Appendix A: Addendum to Design and Access Statement to explain revised scheme - pg 1

Planning Ref: HGY/2022/2212

Revised Scheme
43 Belmont Avenue N17 6AX
Proposed Block plan (showing lower ground floor)
Scale: 1:200@A3 May 2022 **PP_09 revA**

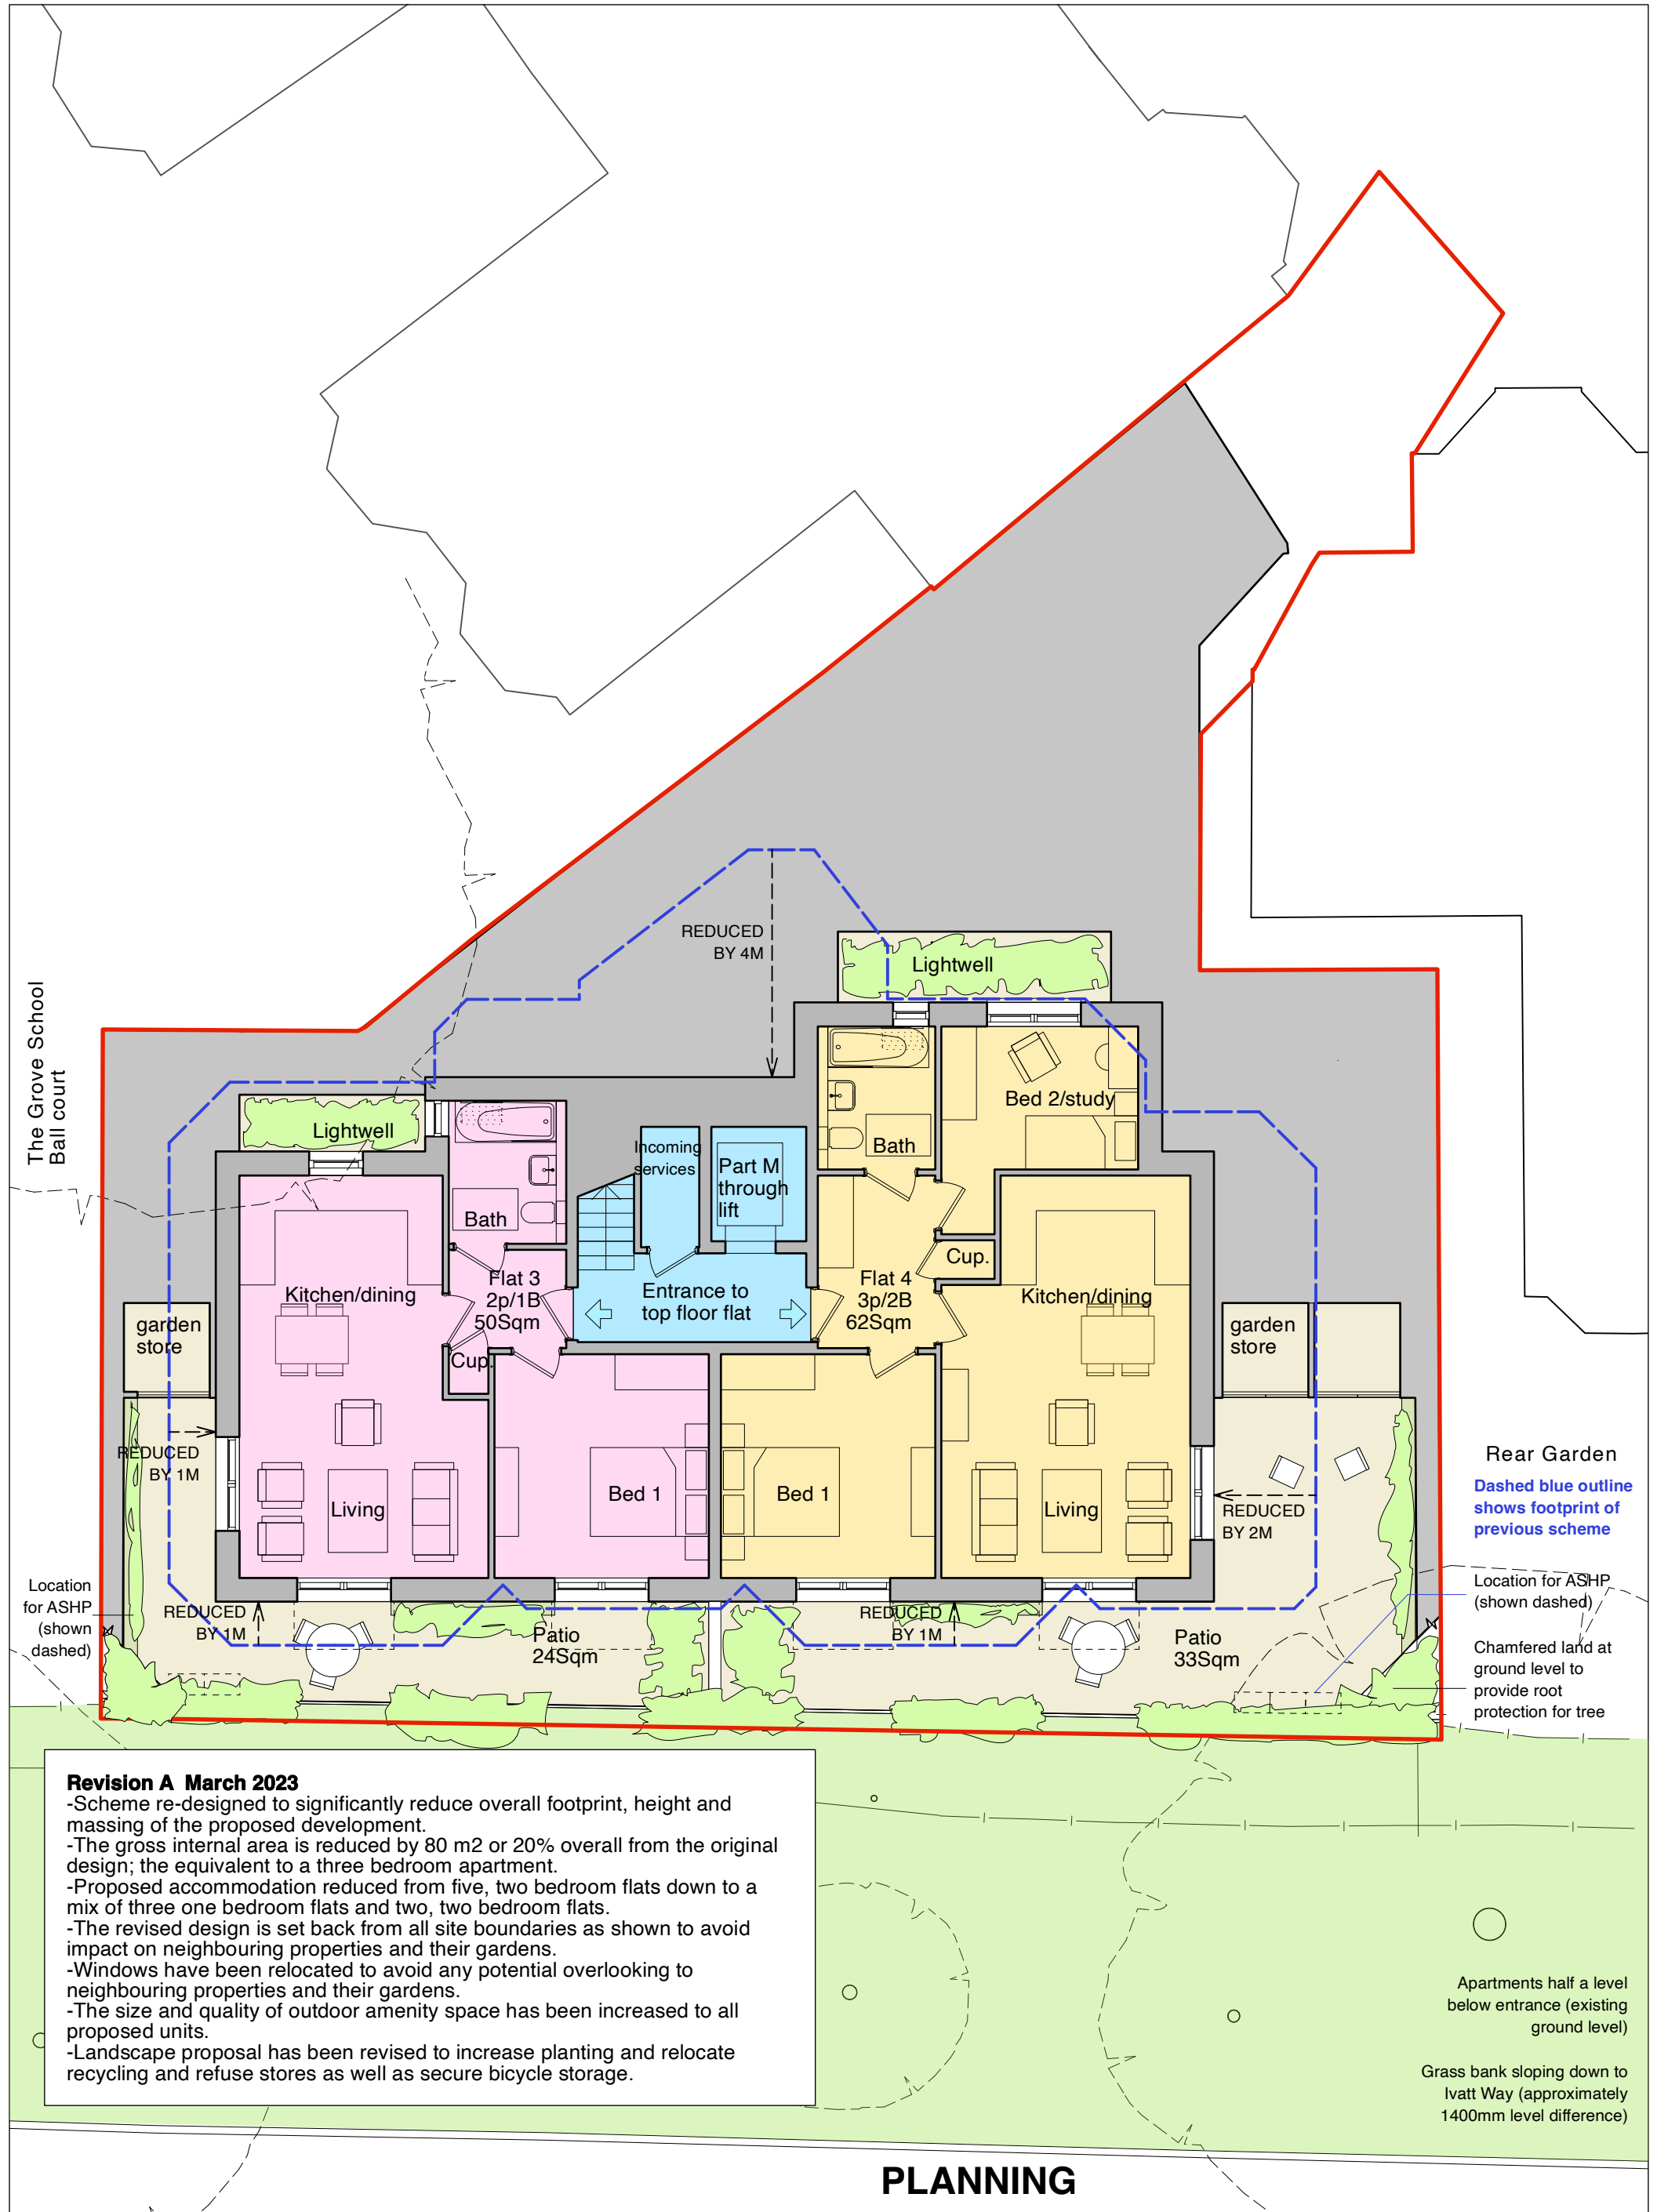
- Scheme re-designed to significantly reduce overall footprint, height and massing of the proposed development.
- The gross internal area is reduced by 80 m² or 20% overall from the original design; the equivalent to a three bedroom apartment.
- Proposed accommodation reduced from five, two bedroom flats down to a mix of three one bedroom flats and two, two bedroom flats.
- The revised design is set back from all site boundaries as shown to avoid impact on neighbouring properties and their gardens.
- Windows have been relocated to avoid any potential overlooking to neighbouring properties and their gardens.
- The size and quality of outdoor amenity space has been increased to all proposed units.
- Landscape proposal has been revised to increase planting and relocate recycling and refuse stores as well as secure bicycle storage.

PP_11 revA

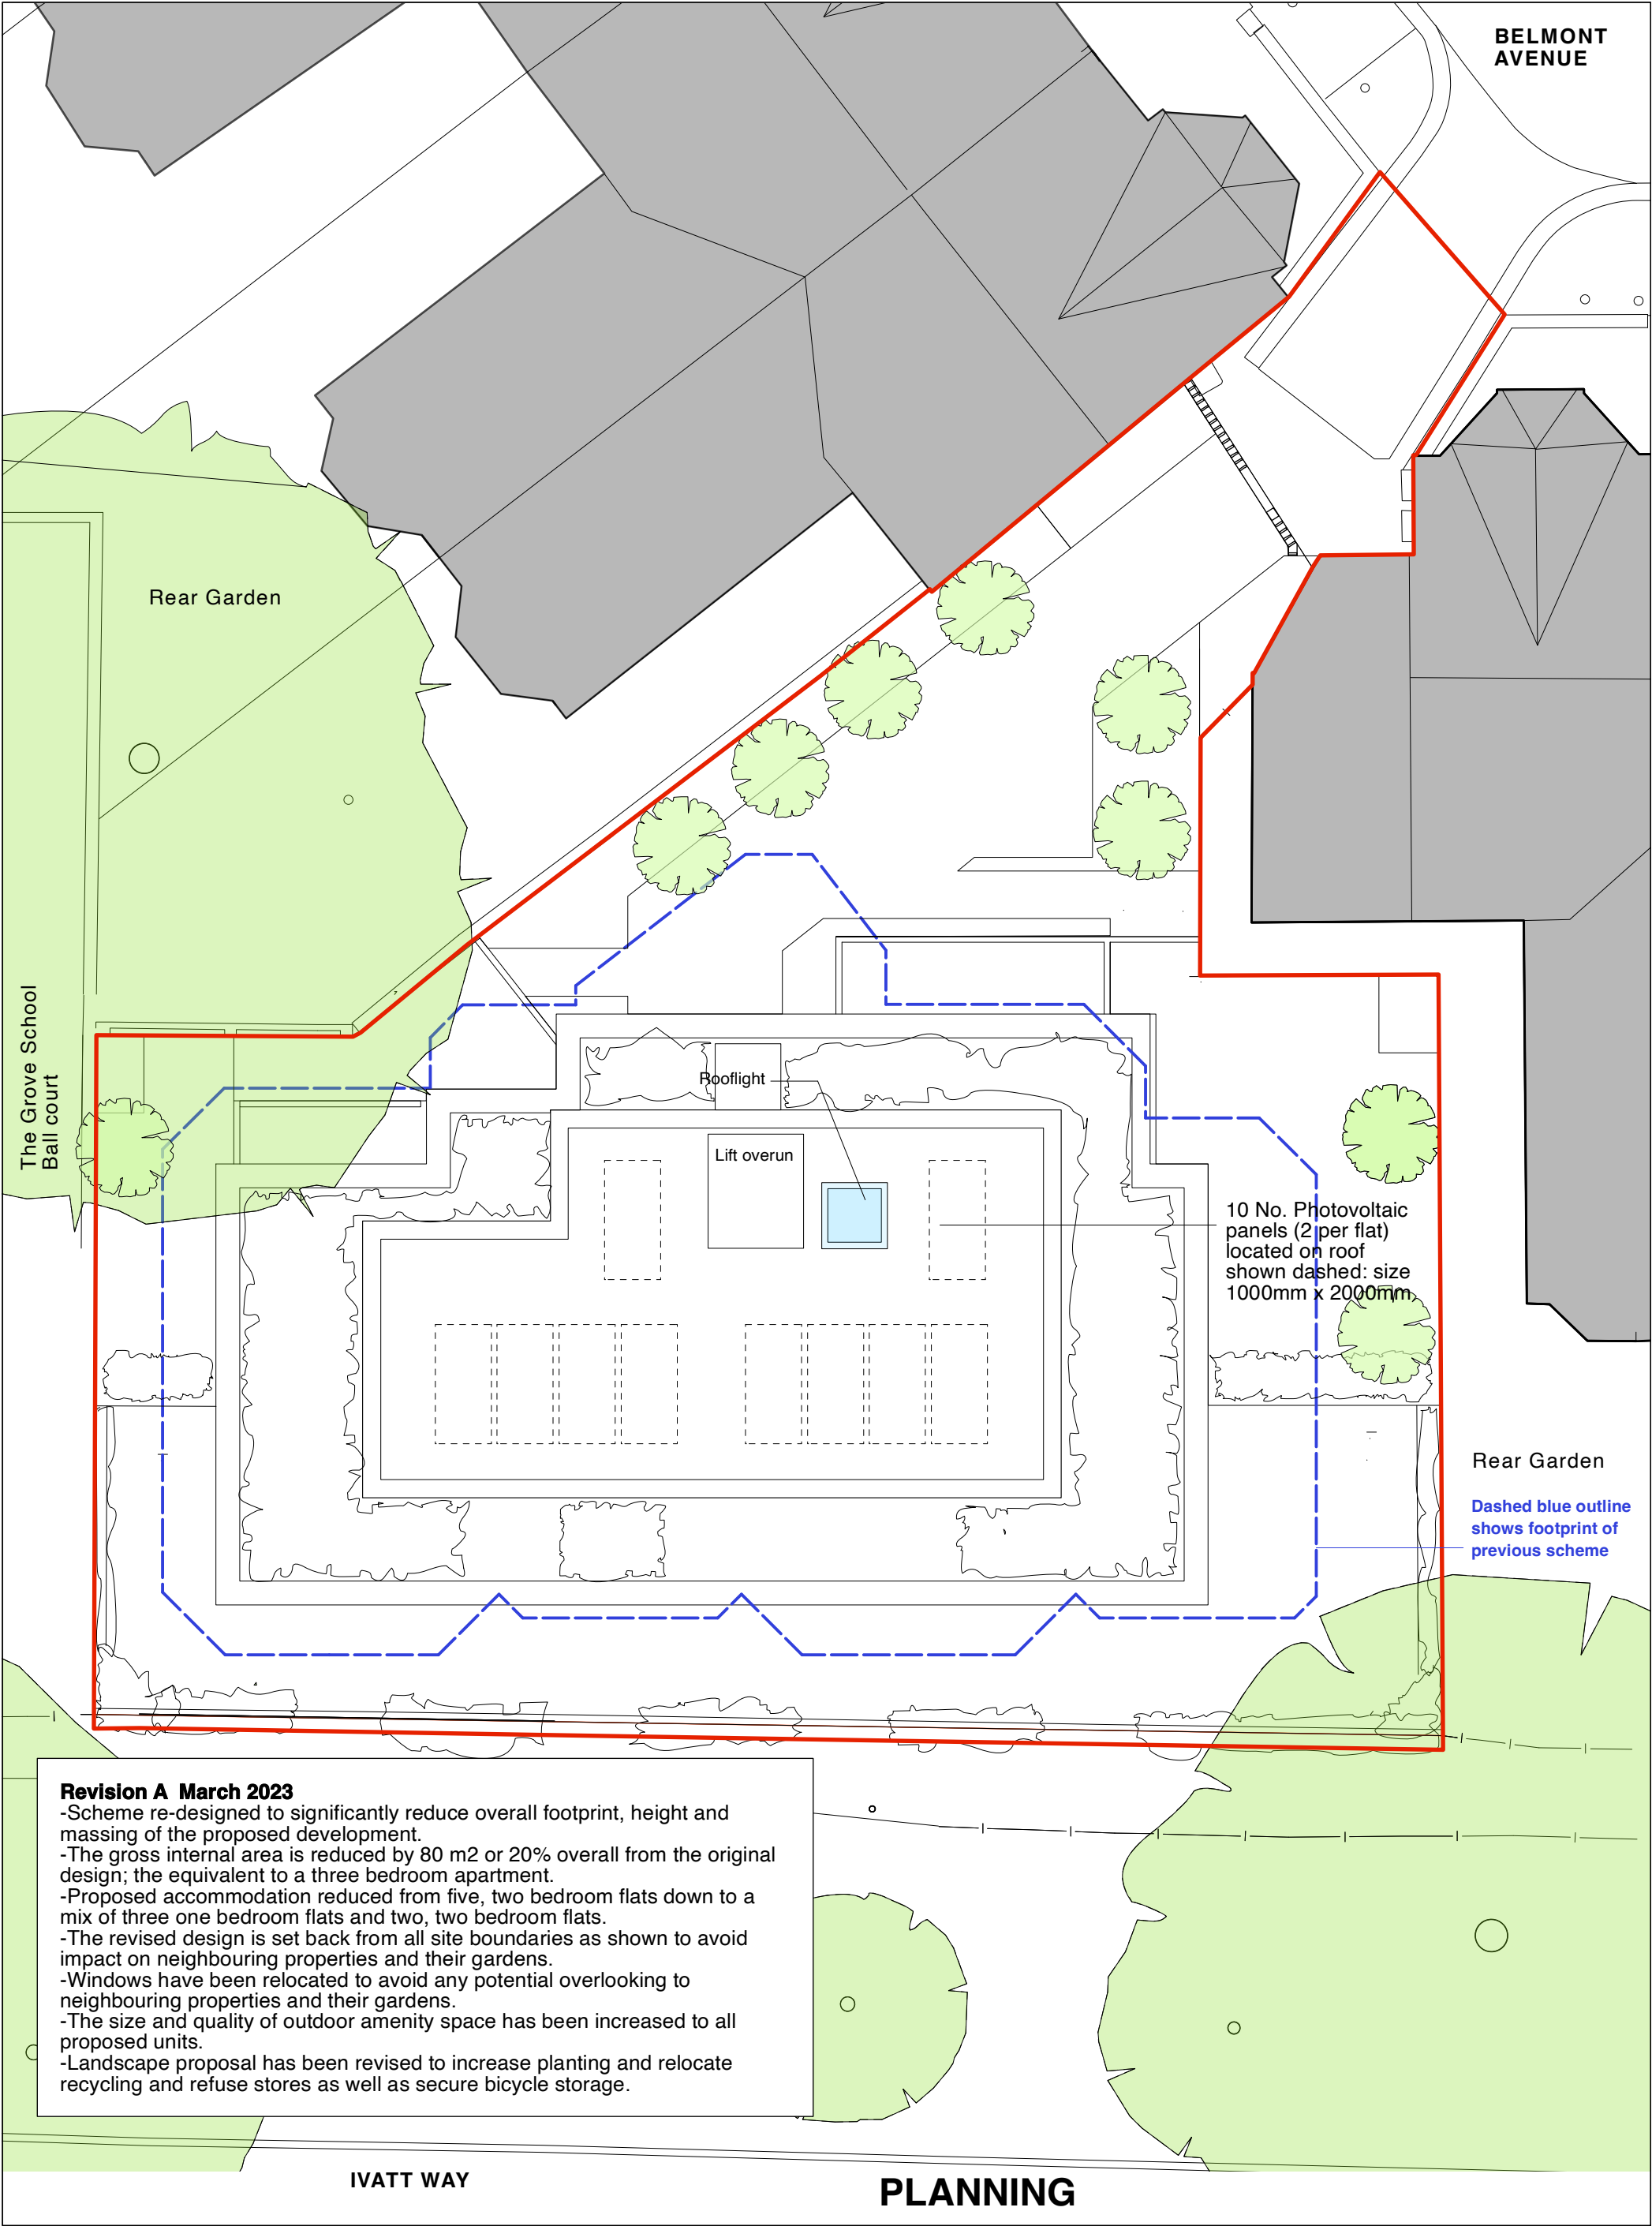
- Scheme re-designed to significantly reduce overall footprint, height and massing of the proposed development.
- The gross internal area is reduced by 80 m2 or 20% overall from the original design; the equivalent to a three bedroom apartment.
- Proposed accommodation reduced from five, two bedroom flats down to a mix of three one bedroom flats and two, two bedroom flats.
- The revised design is set back from all site boundaries as shown to avoid impact on neighbouring properties and their gardens.
- Windows have been relocated to avoid any potential overlooking to neighbouring properties and their gardens.
- The size and quality of outdoor amenity space has been increased to all proposed units.
- Landscape proposal has been revised to increase planting and relocate recycling and refuse stores as well as secure bicycle storage.
